RE: Response to Second Peer Review  
Special Permit, Variance, and Site Plan Review Application  
176 Main Street  
Wareham, MA  
ZBA Case 31-23  
**G.A.F. Job No. 21-9822**

G.A.F. Engineering, Inc., on behalf of our client Warren 176 Main St QOZB, LLC, provides the following responses to the review comments received from Allen & Major Associates, Inc. by letter dated October 6, 2023. Revised plans dated October 11, 2023; are included with the submittal.

## Groundwater Mounding Calculations

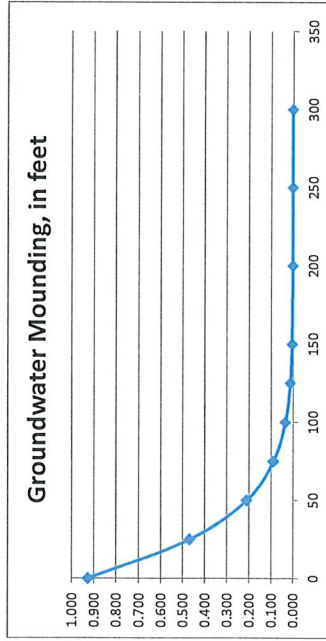
10. After the estimated seasonal high groundwater elevation is confirmed under Comment 9, the applicant is required to provide a groundwater mounding assessment if less than four feet of separation is provided from the bottom of the stormwater system to the confirmed seasonal high water table.

**Updated comment:** Comment remains outstanding.

***We have performed mounding calculations for the drainage system which indicate that the groundwater mound beneath the center of the system will be 0.93 feet. The system would therefore perform as calculated if seasonal high groundwater was present at any elevation below the crushed stone.***

Groundwater Mounding Analysis based on a 2 inch volume 24 hour storm event.  
Basin Exfiltration Rate entered into HydroCAD is 0.27 inches/hour for HSG C soils.

Using the Hantush calculator input  $R = 1.95 \text{ feet/day}$  and  $K = 19.5 \text{ feet/day}$

Groundwater Mound = 0.93 feet at the center of the basin

### Pond 1P: Leaching Pits/Crushed Stone

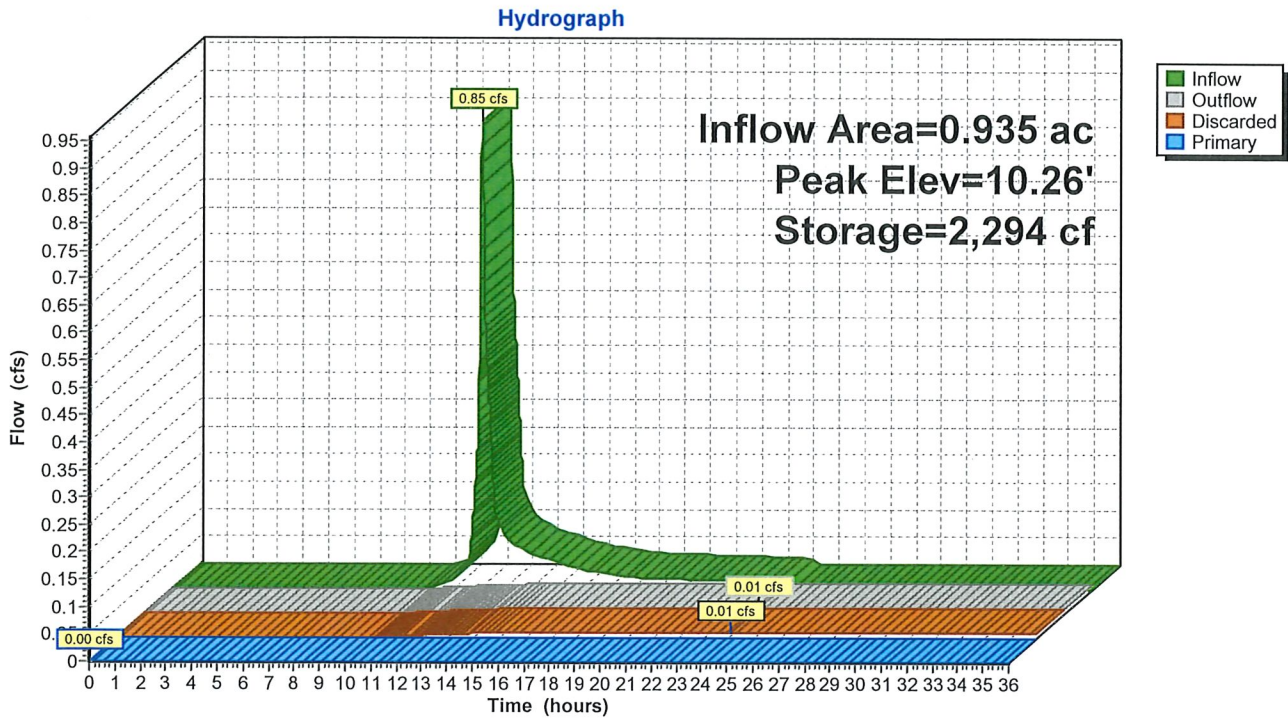
14. It appears that the design engineer is utilizing pond storage in the HydroCAD model in addition to the proposed subsurface leaching pits. The plans do not depict the intended location of this storage on the plan. It appears the parking lot is being used as the ponding area in all storm events. Based on the peak elevations reported in the HydroCAD report, water will be ponding against the building during the 10-year event and greater storm events. This should be clarified or revised. The rear door elevation is listed at 12.5 while the 100 year ponding in this area is at 12.79.

**Updated comment:** The response letter notes the use of a broad crested weir at elevation 12.3 on the northerly side of the building. A&M concurs with this from the prior HydroCAD model. However, the model notes that with the weir discharging during the 100-year storm, the water elevation will rise to elevation 12.79 and conflict with the door elevation. Understanding that during a 100-year event there are large areas of ponding that do occur, but the model directly indicates the building entry will be unusable as well as the rear parking areas that includes the only accessible parking spaces onsite.

***We disagree with the above characterization of the condition of the parking lot during storm events. Peak inflow and discharge rates that are calculated for Type III storm events have a duration of less than an hour. The resulting peak storm elevations dissipate in under an hour. The design also includes an outlet pipe set at elevation 9.3 which will provide a primary means of discharge that is three feet below the surface overflow on the north side of the building and will assist in ensuring full use of the parking lot during all calculated storm events.***
